STATE OF CONNECTICUT  
CONNECTICUT SITING COUNCIL

IN RE: :  
 :  
APPLICATION OF HOMELAND TOWERS : DOCKET NO. 507  
LLC AND CELLCO PARTNERSHIP D/B/A :  
VERIZON WIRELESS FOR A CERTIFICATE :  
OF ENVIRONMENTAL COMPATIBILITY :  
AND PUBLIC NEED FOR THE :  
CONSTRUCTION, MAINTENANCE AND :  
OPERATION OF A WIRELESS :  
TELECOMMUNICATIONS FACILITY AT :  
222 CLINTONVILLE ROAD, NORTH :  
BRANFORD, CONNECTICUT : MARCH 24, 2022

LATE FILE EXHIBITS

**Existing and Proposed Verizon Wireless 1900 MHz Coverage**  
**Northford, Connecticut and Surrounding Area**  
 (\*Map Scale is 1:24,000)

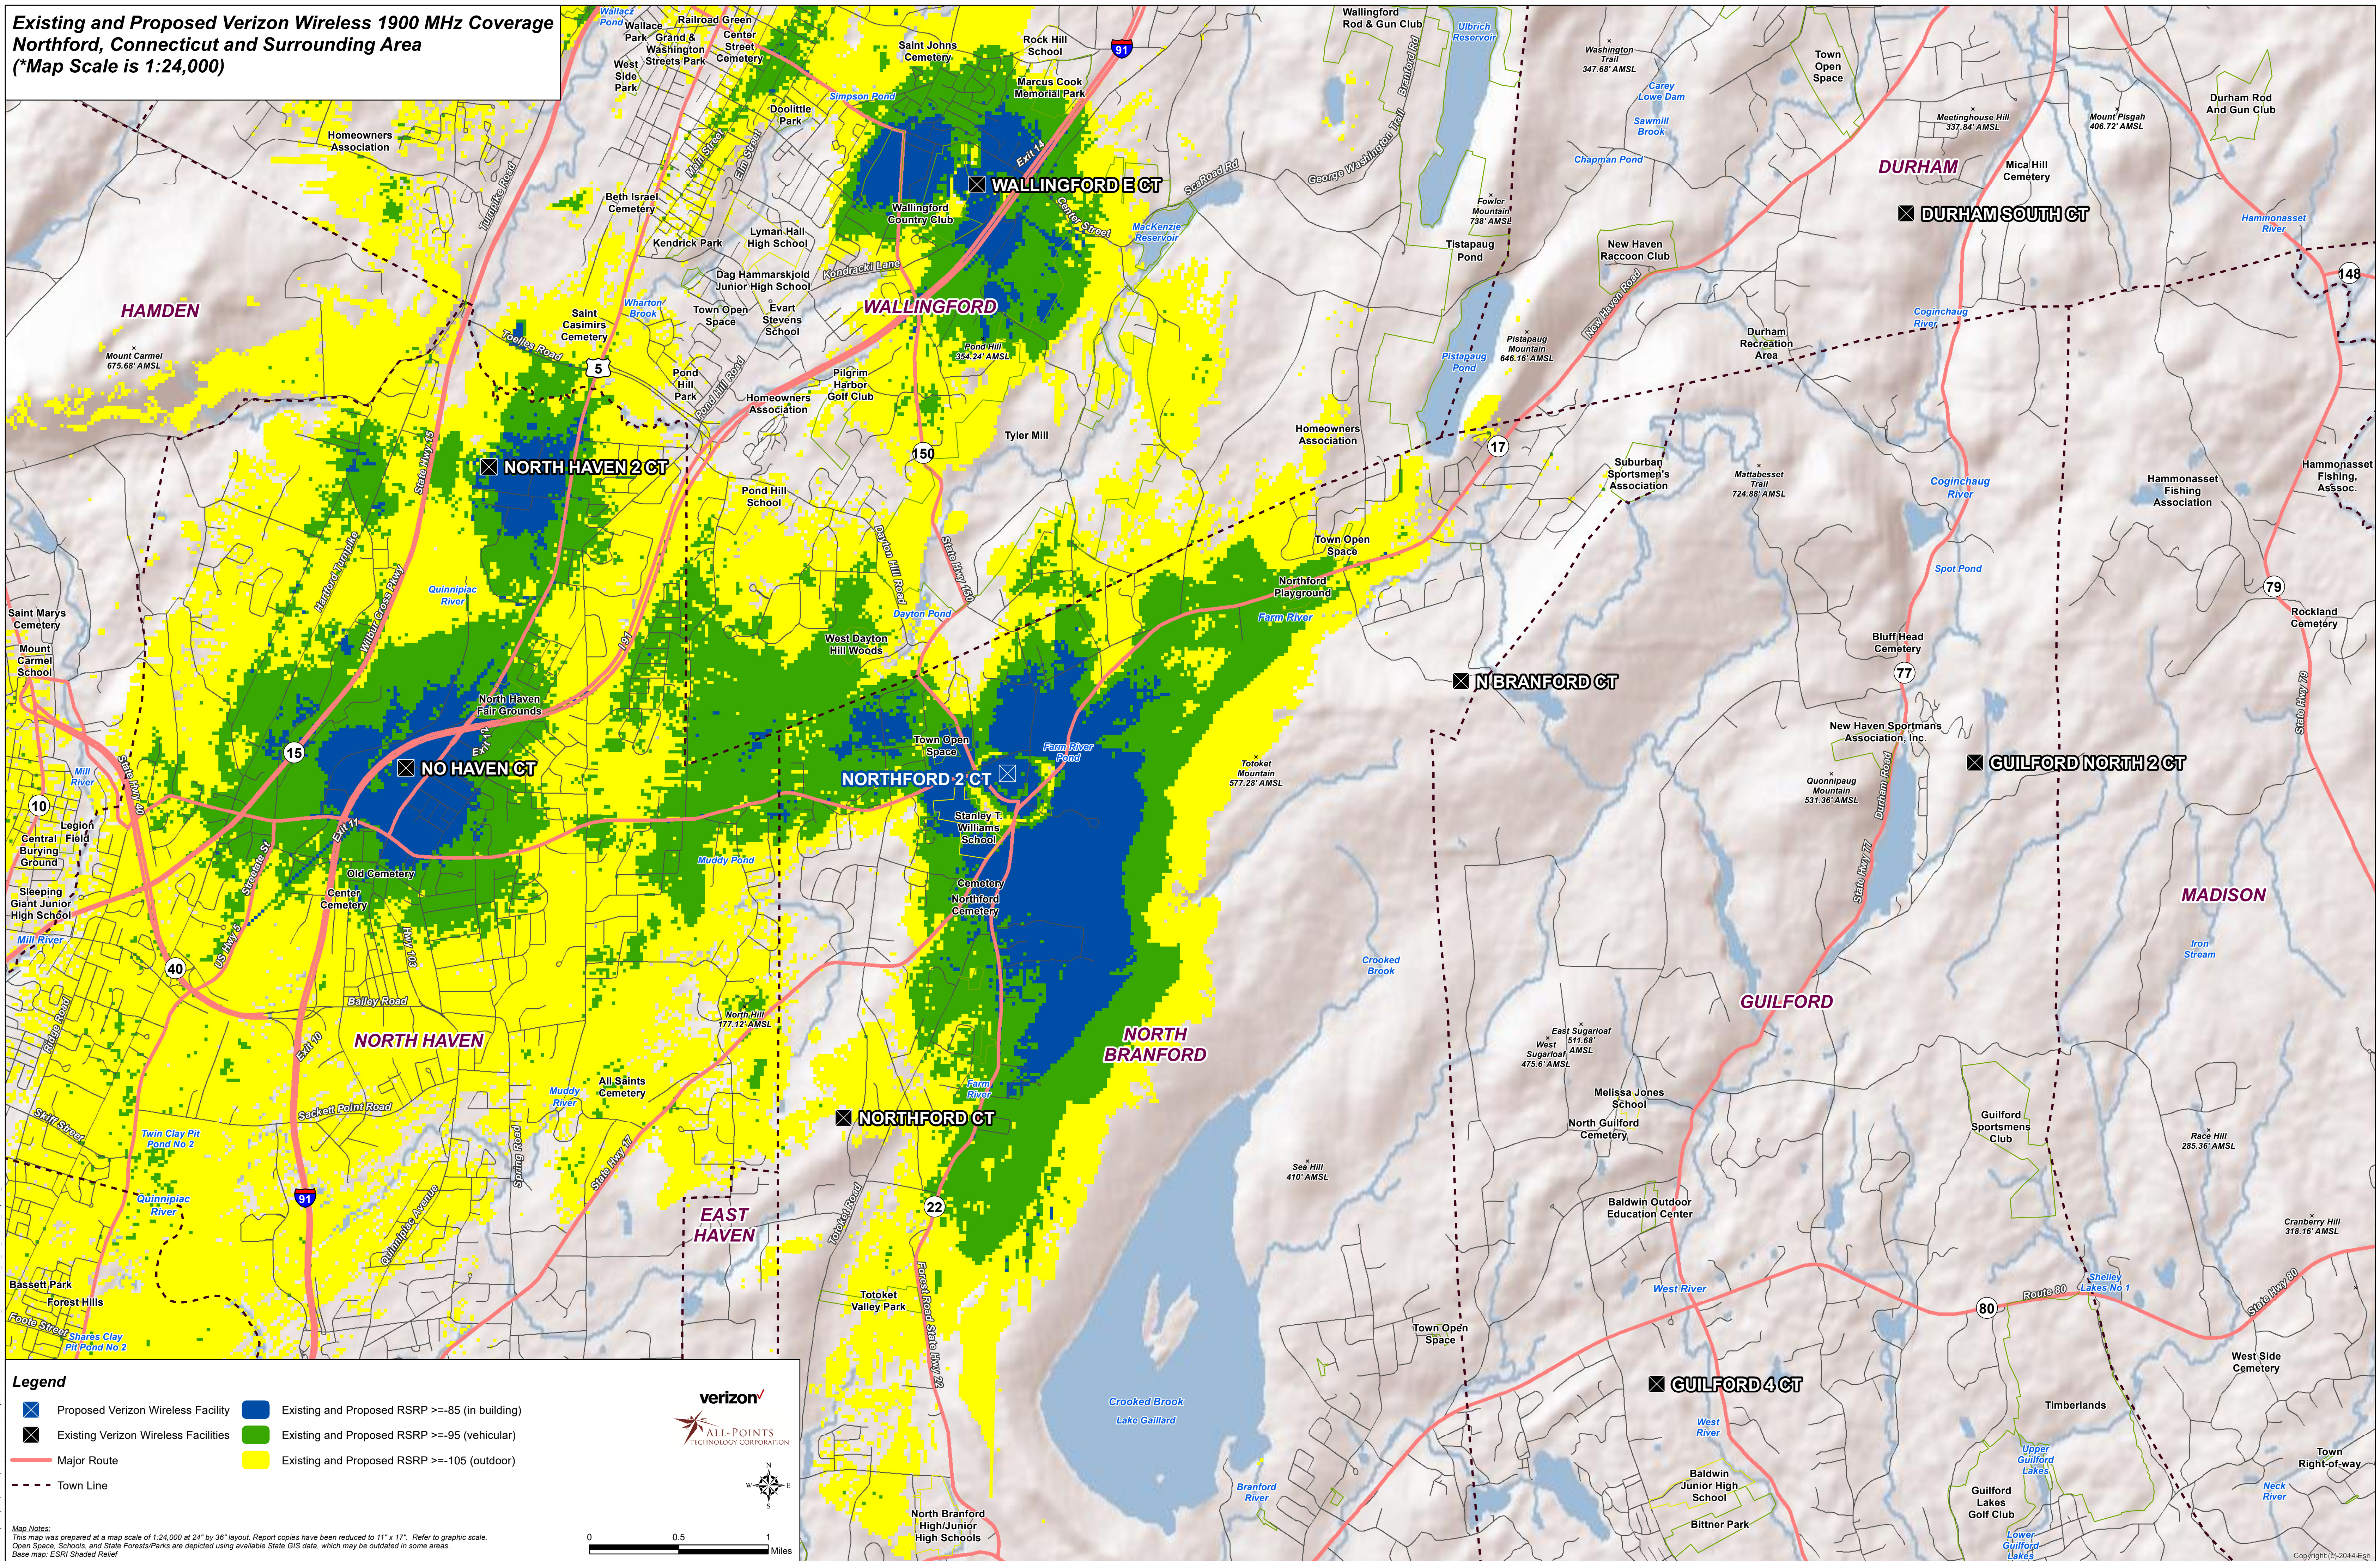
In response to Mr. Morrisette’s request, attached is a revised “Existing and Proposed Verizon Wireless 1900 MHz Coverage” plot for the proposed Northford 2 Facility. At the hearing, RF Engineer Ziad Cheiban, explained that the “Existing and Proposed 1900 MHz Coverage” plot included behind Tab 6 of the Application showed that Cellco’s existing Northford Facility was currently providing service at 1900 MHz which, at the time of the hearing, was not the case. The corrected plot attached shows existing and proposed 1900 MHz service from Cellco’s existing North Haven, North Haven 2 and Wallingford cell sites together with 1900 MHz service form the “proposed” Northford 2 Facility.
